June 8, 2022

Re: Windler Neighborhood Planning Area 7, 8- Response to Pre-Application Meeting

Thank you for your comments regarding the pre-application meeting for Windler Neighborhood C. The following are staff comments dated May 20, 2022 from the Development Review Team. Olsson/LandOne (civil) responses are in **RED** text. Civitas (landscape/planning) responses are in **BLUE** text.

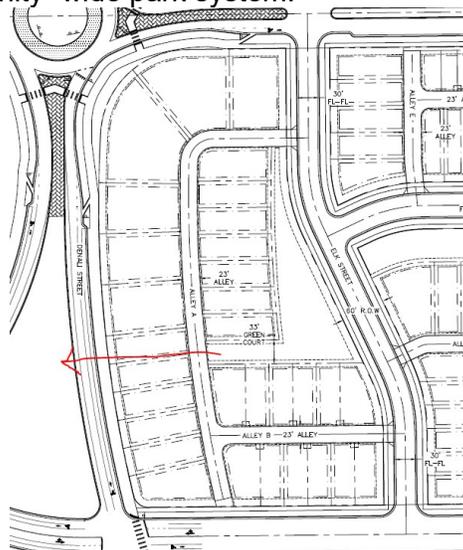
Establishing a hierarchy of streets will also be helpful in addressing building orientation for proposed lots. The proposed street network within PA-7 includes frequent reverse corner lots, and street environments where buildings are facing side elevations across the street (refer to a couple of examples below). Though they are likely to occur in neighborhoods with good block connectivity, buildings/lots should be designed to orient towards each other as much as possible. Corner side elevations should be enhanced to help improve

interaction and appearance to the street with second entries, side-yard porches, or other façade elements. Fencing in these areas also need to be carefully addressed to prevent front yard disruptions with the adjacent block.

Corner lot building side elevations will be enhanced to help improve interaction and appearance to the street with second entries, side-yard porches, or other façade elements. Fencing in these areas will be set back further back from corner property line to prevent front yard disruptions with the adjacent block and to give enough space for corner lot landscaping.
